Re: 22-027B Softball Complex, Sulphur Springs Park  
**Proposed Change Request 3: Repair one Area of Erosion/Benchmark dwg \$12,657.11**

**Softball Complex - PCR 3**

Adding Junction Box to existing Storm Drainage at Lake  
per drawing from Benchmark Engineering dated 10.18.24

Softball Complex  
Sulphur Springs Park - PCR 3

JUNCTION BOX FRAME AND COVER

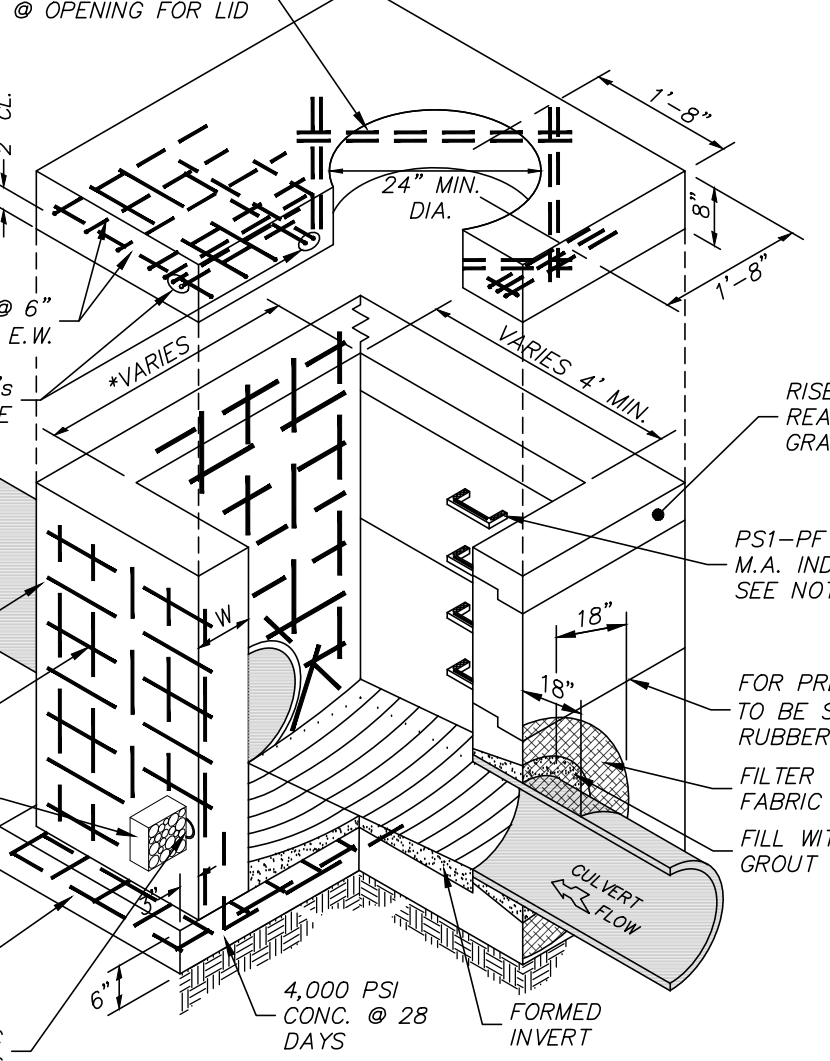
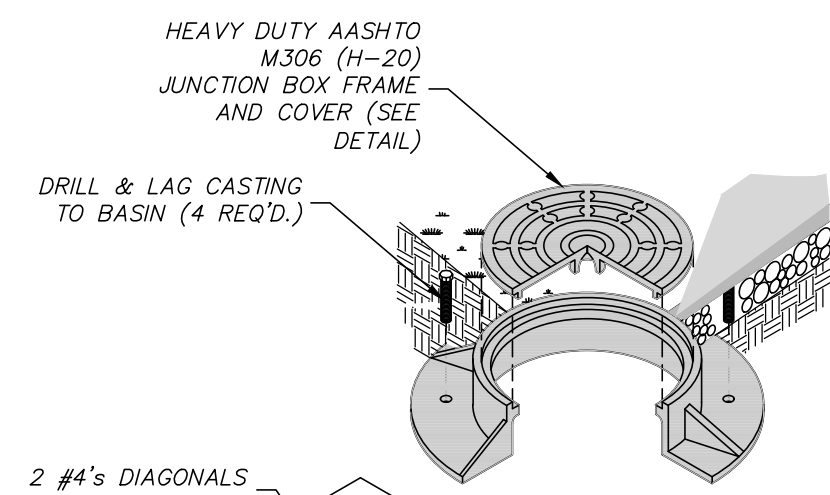
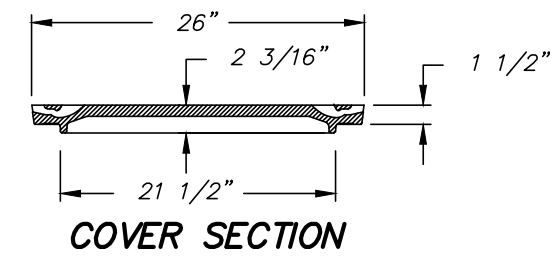
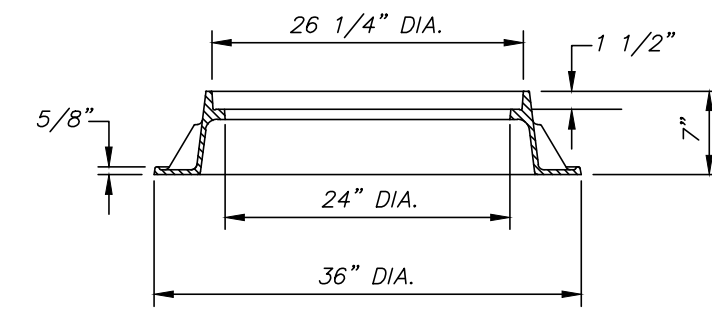
Excavate 2' Horizontally Beyond limit of Eroded area & Fill with select material. Remove 9 feet of existing storm drain. Add 11 LF of 24" HDPE Storm Drain. Install a Junction box. Connect Existing storm drain with concrete Collar. Treat Slope with additional 78 SY of Landlock 450.
